ZONING SITE PLAN FOR:
 URBAN TRUCKING

PETITION NO: Z-38

PROPOSED USE: Truck Terminal and
Truck Repair Facility

ZONING COMMENTS:

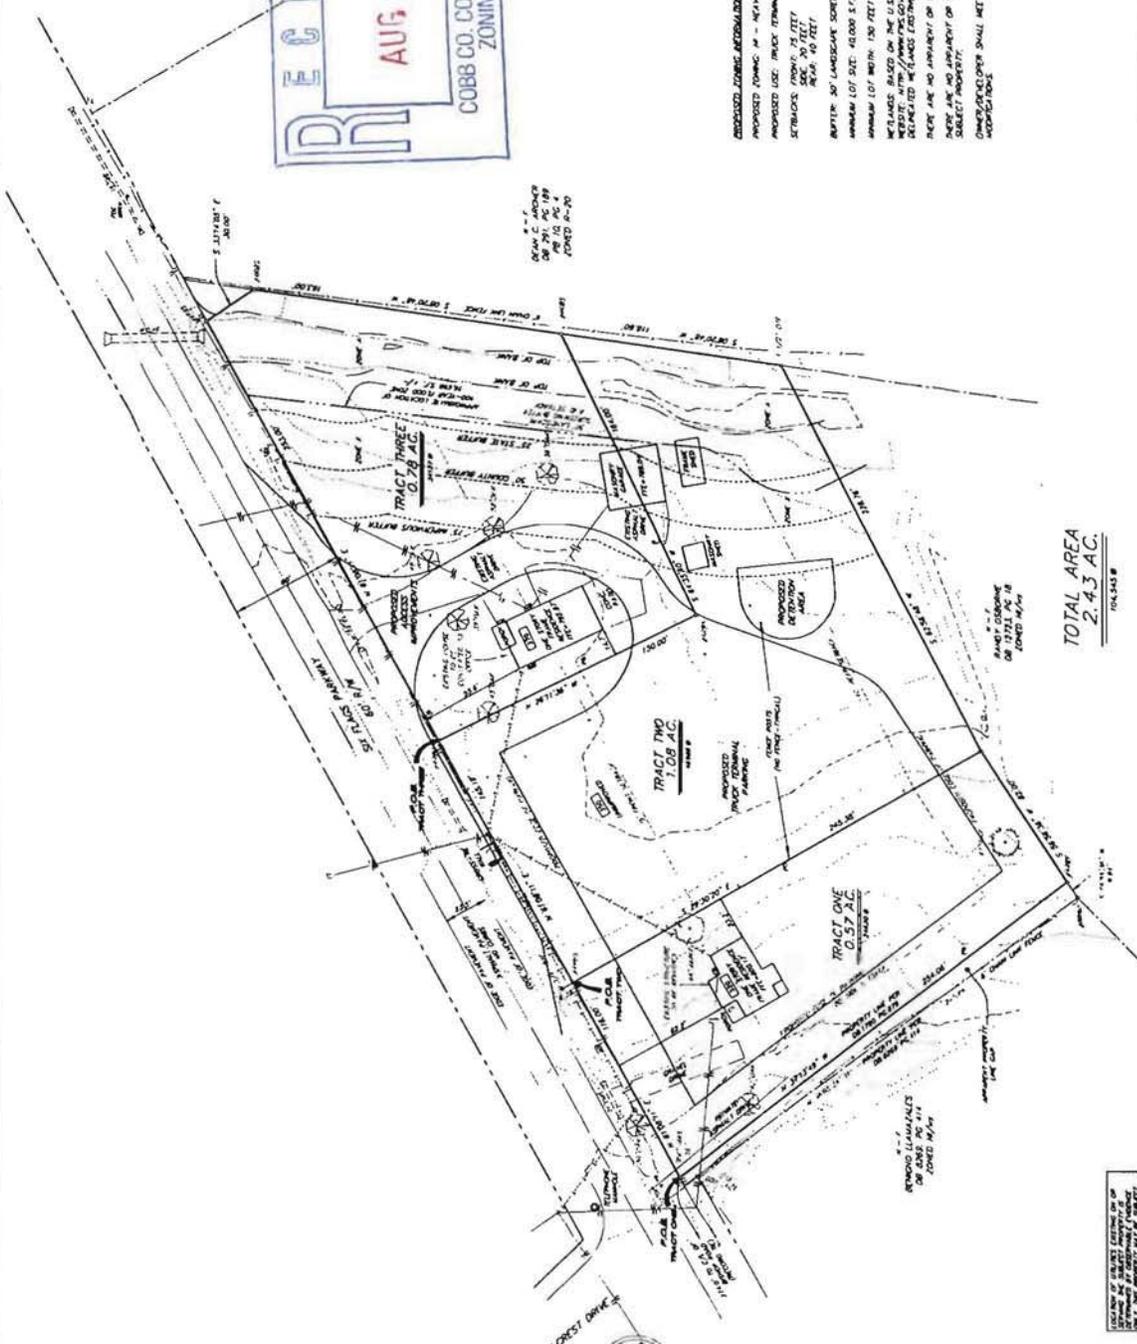
- Provide comprehensive hydrology/stormwater controls to include development of out parcels.
- Submit all proposed site improvements to Plan Review.
- Any **spring activity** uncovered must be addressed by a qualified geotechnical engineer (PE).
- Structural fill _____ must be placed under the direction of a qualified registered Georgia geotechnical engineer (PE).
- Existing facility.
- Project must comply with the Water Quality requirements of the CWA-NPDES-NPS Permit and County Water Quality Ordinance.
- Water Quality/Quantity contributions of the existing lake/pond on site must be continued as baseline conditions into proposed project.
- Calculate and provide % impervious of project site.
- Revisit design; reduce pavement area to reduce runoff and pollution.

- No Stormwater controls shown _____
- Copy of survey is not current – Additional comments may be forthcoming when current site conditions are exposed.
- No site improvements showing on exhibit.

1. A commercial truck repair facility is considered a stormwater quality “hot-spot” due to the potential for discharge of contaminated runoff. The installation of an oil/water separation device will be required to treat runoff from this site. The development of a written stormwater pollution prevention plan (SWPPP) will also be required for the site.

Six Flags Parkway is classified as a major collector and according to the available information the existing right-of-way does not meet the minimum requirements for this classification.

Recommend applicant consider entering into a development agreement pursuant of O.C.G.A. 36-71-13 for dedication of the following system improvements to mitigate traffic concerns: a) donation of right-of-way on the south side of Six Flags Parkway, a minimum of 40' from the roadway centerline.

Recommend one access to Six Flags Parkway.

Recommend applicant verify that minimum intersection sight distance is available and if it is not, implement remedial measures, subject to the Department's approval, to achieve the minimum requirement.

Recommend curb, gutter, and sidewalk along Six Flags Parkway frontage.

Recommend a deceleration lane on Six Flags Parkway for the entrance.

- Site plan received by the Zoning Division on August 22, 2012, with the District Commissioner approving minor modifications;
- Water and Sewer comments and recommendations;
- Stormwater Management comments and recommendations;
- DOT comments and recommendations;
- Owner/developer to enter into a Development Agreement pursuant to O.C.G.A. §36-71-13 for dedication of system improvements to mitigate traffic concerns.
